STAFF REPORT

DATE: MARCH 17, 2026
TO: PLANNING COMMISSION
FROM: KATRINA KAWAGOE, SENIOR PLANNER
SUBJECT: PLANNING APPLICATION NO. 250434
APPLICANT: JOHN V. JUGE, ARCH-SCAPE LLC
LOCATION: 4605 MARLOMA DRIVE

A request for a Neighborhood Compatibility Determination (NC-260059) for a front yard covered porch addition to a single-story, single-family home; and two Minor Deviations (MD-250435, MD-250436) for the 38 SF encroachment into an existing front yard setback, which does not project closer to the front property line than the forwardmost building line and for the decrease of a required front yard by less than 10%.

Figure 1: Proposed Site Plan

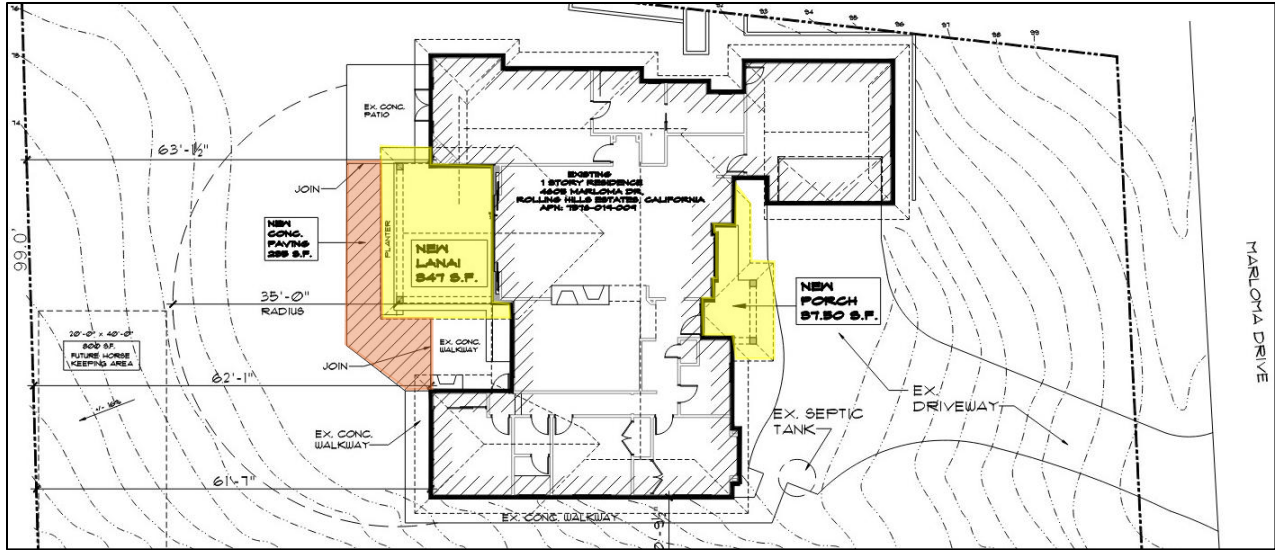
The project also includes the construction of a new front porch intended to frame the primary entryway to the home. The proposed porch would encroach 37.5 SF into the required front yard setback and therefore requires approval of a Minor Deviation. The porch will have a maximum height of 10'-10" from finished grade to the top of the ridge.

deviations from this prohibition. The project proposes to construct a new entry porch with a gabled roof that would encroach 3'-9" into the front yard, but not closer to the front property line than the forwardmost building line. This entry porch encroachment would also decrease the front yard area by less than 1%.

Staff can support the Minor Deviations because the proposal is consistent with the City's General Plan, does not conflict with any other provisions of the zoning ordinance, and does not adversely affect surrounding properties or the property of the applicant.
